**City of Santa Cruz**  
**Addendum to Certified Environmental Impact Report**  
Newell Creek Dam Inlet/Outlet Replacement Project  
State Clearinghouse Number: 2018062071  
June 2021

**Project Title:** Newell Creek Dam Inlet/Outlet Replacement Project

FIGURE 5

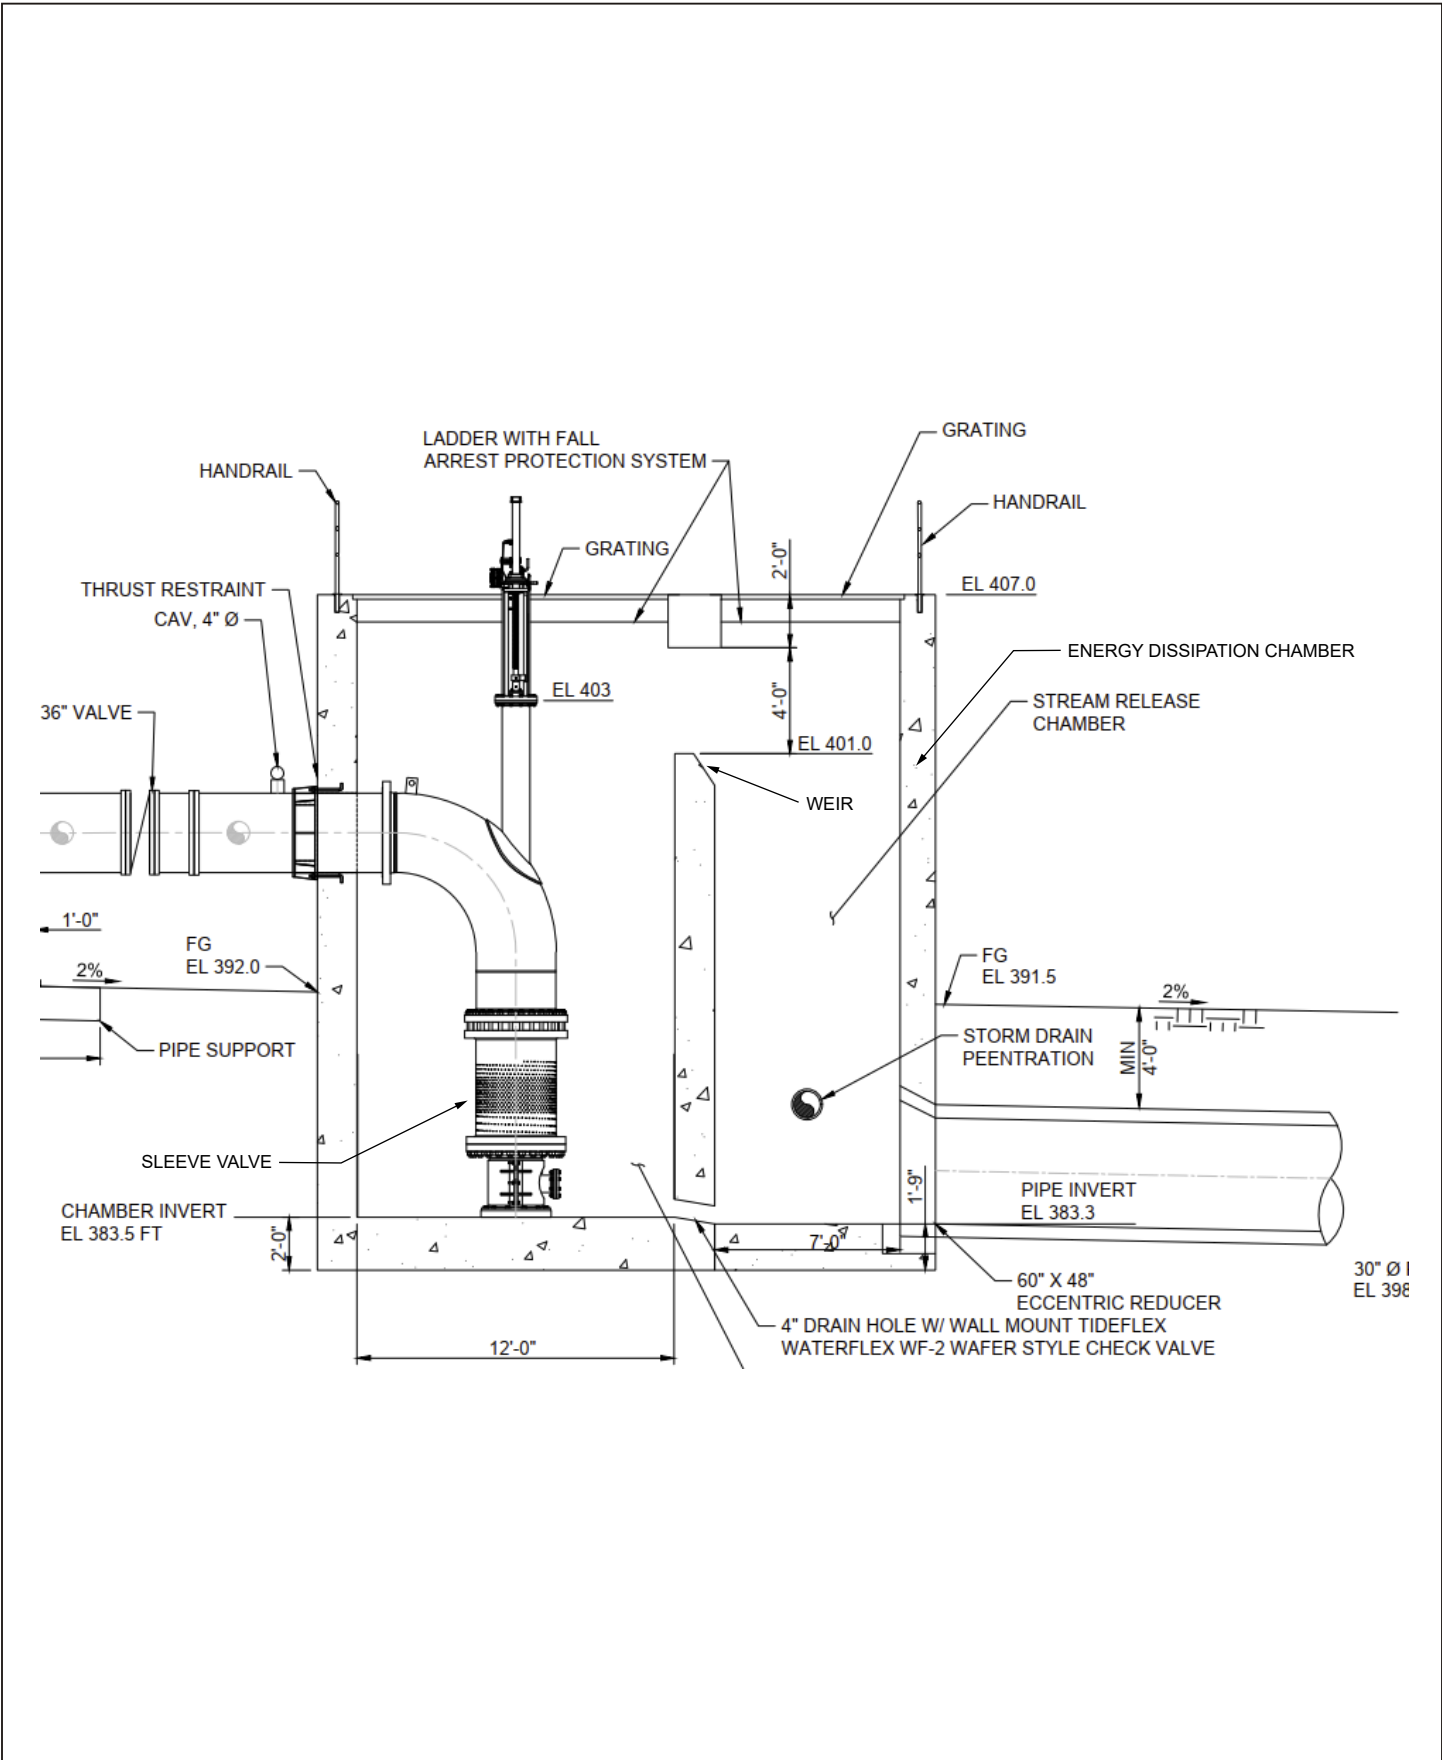
The proposed Project modifications consist of a change to the maximum discharge rate of the outlet structure with a control to be installed on the new outlet discharge sleeve valve to provide a revised maximum emergency release rate of 203 cubic feet per second (cfs). This represents an increase of approximately 39 cfs above the maximum emergency release rate of 164 cfs that was evaluated in the EIR. The change is necessary to allow the valve to initially facilitate releases greater than the required emergency release rate in order for the facility to continue to meet drawdown requirements even with some anticipated diminished capacity as the facility ages. Additionally, the velocity through the valve, which was modeled to have a theoretical maximum flow of 272 cfs, would be 38.5 feet/second (ft/s), however, the valve manufacturer does not recommend operating the valve at velocities higher than 30 ft/s for extended periods of time in order to minimize the potential for damage to the valve's internal parts.

The valve will be manufactured with a mechanical valve stop (clamp/bolts) that will limit the release to the 203 cfs maximum amount. This will ensure that the velocity through the sleeve valve will be less than the manufacturer's recommended maximum of 30 ft/s (AECOM 2021a). Operationally, the City may be required to fully open the valve during DSOD inspections/testing, but would only test the valve when the Reservoir is spilling or can make arrangements with DSOD to inspect and test the valve in the dry season without releasing water through the valve. In emergency conditions, the valve would be fully opened regardless of whether or not the Reservoir is spilling.

The new flow rate was determined by updated hydraulic modeling conducted by the Project design engineer (AECOM 2021a) to determine the hydraulic capacity of the outlet structure and maximum discharge rate if all three inlet valves and the outlet sleeve valve were fully open. As water is discharged from the sleeve valve in the outlet structure it flows over a weir separating the energy dissipation chamber from the downstream instream beneficial release chamber. From the downstream chamber, water flows into a 48-inch diameter reinforced concrete pipe and then discharges into the spillway plunge pool (see Figure 5). If the water level in the structure rises too high it could be discharged through the grating on the top of the structure. There is a 4-foot clearance above the weir and another 2 feet of freeboard before water would splash through the grating.

In order to meet the manufacturer's valve velocity recommendation, the proposed Project modifications include the addition of a physical stop to the sleeve valve to ensure that at maximum Reservoir head, with all inlet and outlet valves open, flows would not exceed 203 cfs, and any
